# TECHNICAL SERVICE BULLETIN

## XL/XLT - Instrument Panel Warped/Separated At Defrost Vents

**20-2268**  
18 May 2021

<b>Ford</b> 2015-2020 F-150
--------------------------------

Figure 1

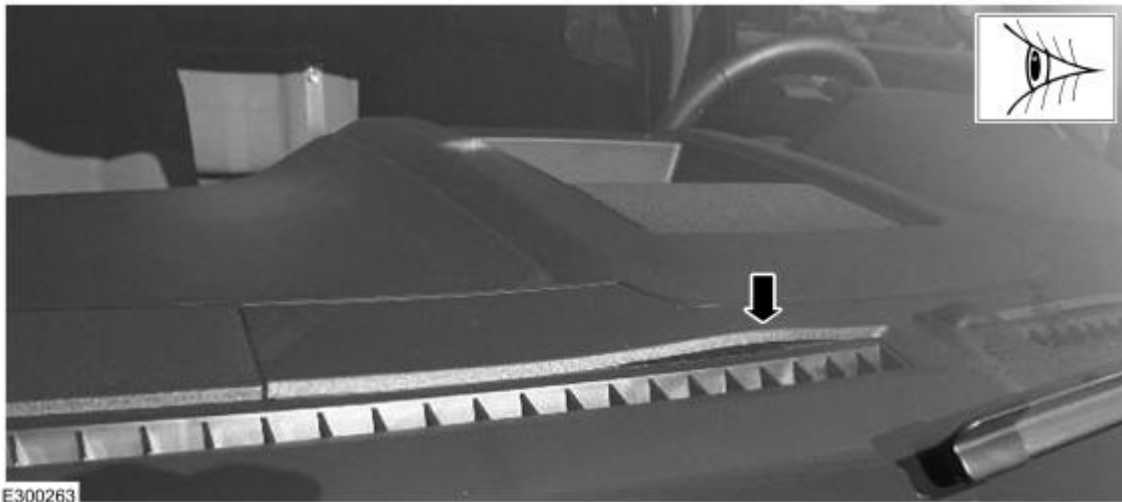
1. Inspect the instrument panel. Does the instrument panel exhibit a warp/separation at the defrost vent as shown in Figures 1-2?

2. Replace the instrument panel upper section. Refer to WSM, Section 501-12.
